Groundwater Transfer Review Summary Form

Transfer/PA # T- 14588

Application: T-14588

Applicant Name: Leighty LT

T14588 Leighty LT

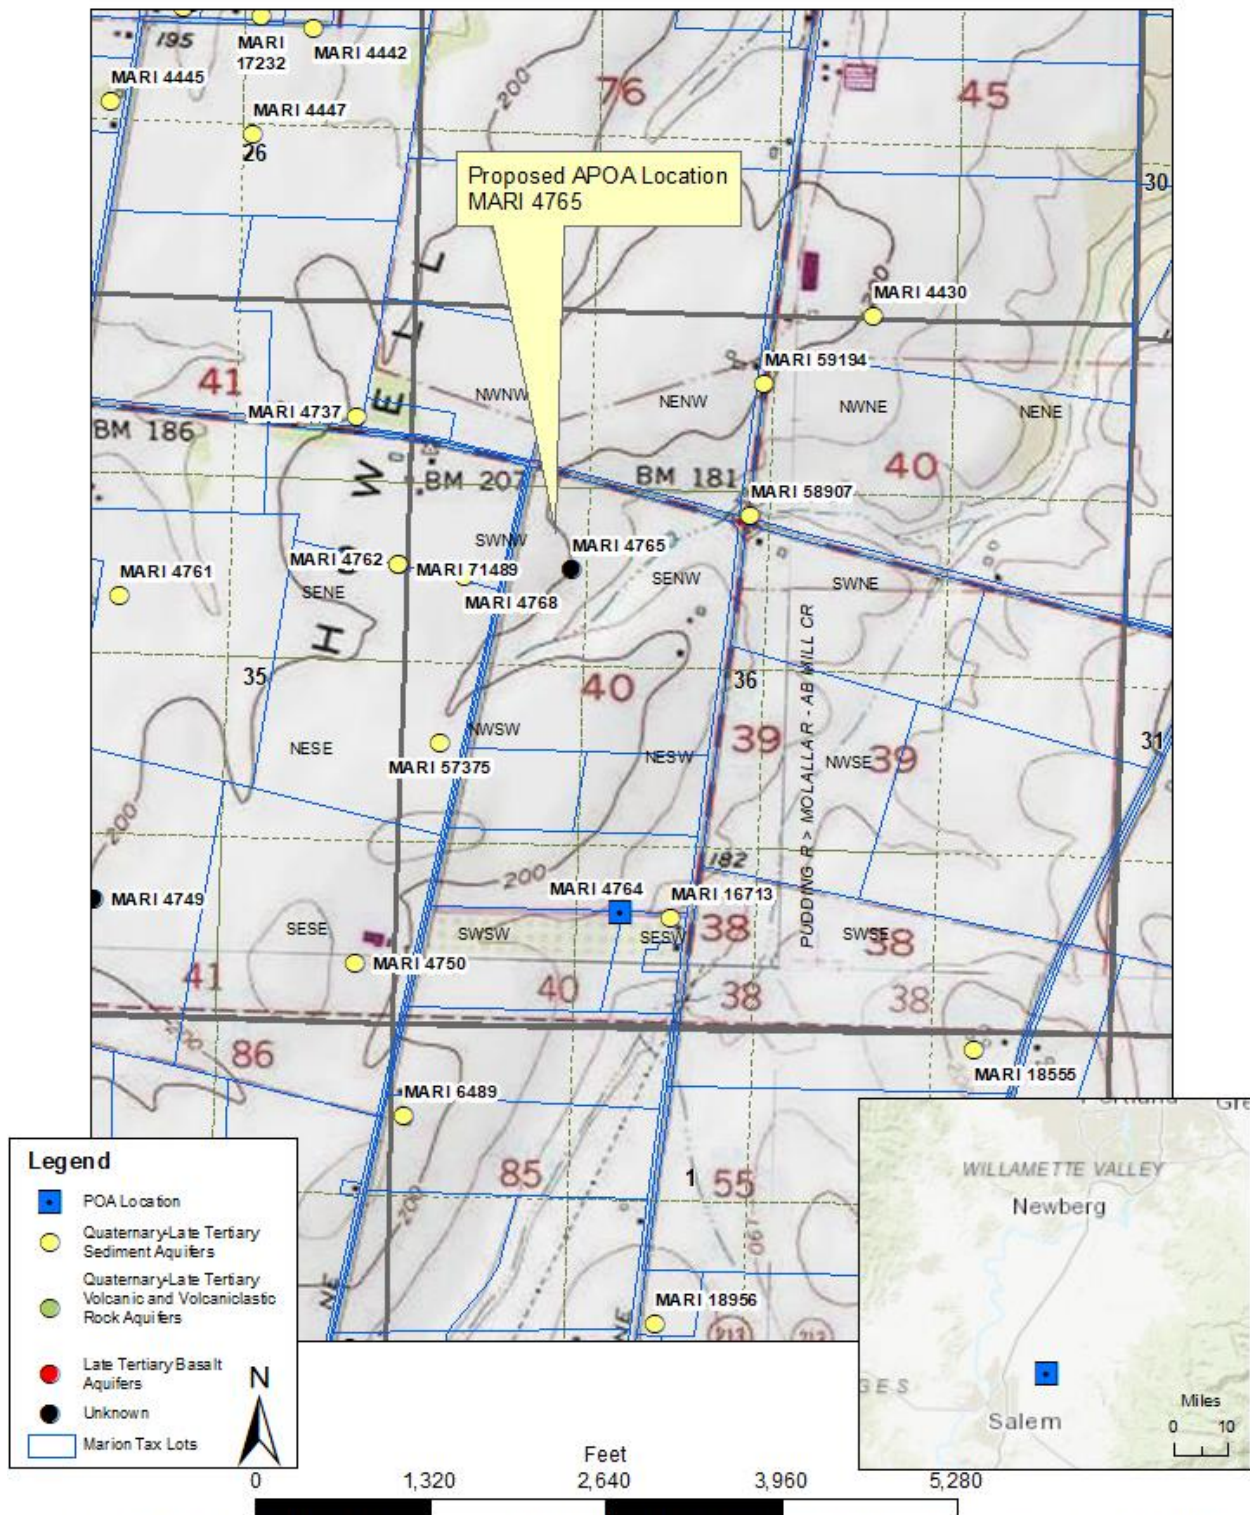
1. Basic description of the changes proposed in this transfer: This proposed transfer pertains to one certificate, 76296. Certificate 76296 is for primary irrigation of 75.1 acres from one POA (MARI 4764, JANZ Well) with a maximum rate of 0.65 cfs. The proposed changes on **Certificate 76296** are the addition of one new groundwater Point of Appropriation (POA) as indicated below:

- Authorized POA: MARI 4764 (JANZ Well)
- Proposed Additional POAs (APOA): MARI 4765 (Proposed Well 1)

2. Will the proposed POA develop the same aquifer (source) as the existing authorized POA?
☒ Yes ☐ No Comments: The authorized POA (MARI 4764) is cased to 386 feet below ground surface (bgs) into decomposed basalt. However, the well is only sealed to 18 feet bgs and the casing is perforated from 75 to 170. Therefore, the authorized POA is completed in the sand and gravel layers of the alluvial aquifer.

The proposed APOA (MARI 4765) is sealed to 35 bgs and cased to 212 feet bgs. There are two sets of perforations from 105 to 135 and 145 to 199 feet bgs. Therefore the APOA is also completed in the alluvial aquifer.

5. a) Will this proposed change, at its maximum allowed rate of use, likely result in an increase in interference with **another ground water right**?
☐ Yes ☒ No Comments: All POAs indicated on this application are similar distances to other groundwater POAs. The additional POA is already authorized POAs on Certificate 56264. Any slight increase of impact on wells closer to the APOA will be negated by the loss of impact from the existing POA, since the authorized POA is relatively closer to nearby groundwater rights than the APOA is.

8. What conditions or other changes in the application are necessary to address any potential issues identified above: The additional POAs are authorized wells on other Certificates. To protect the resource, the new certificate should include water level measurement requirements as part of approving this transfer.
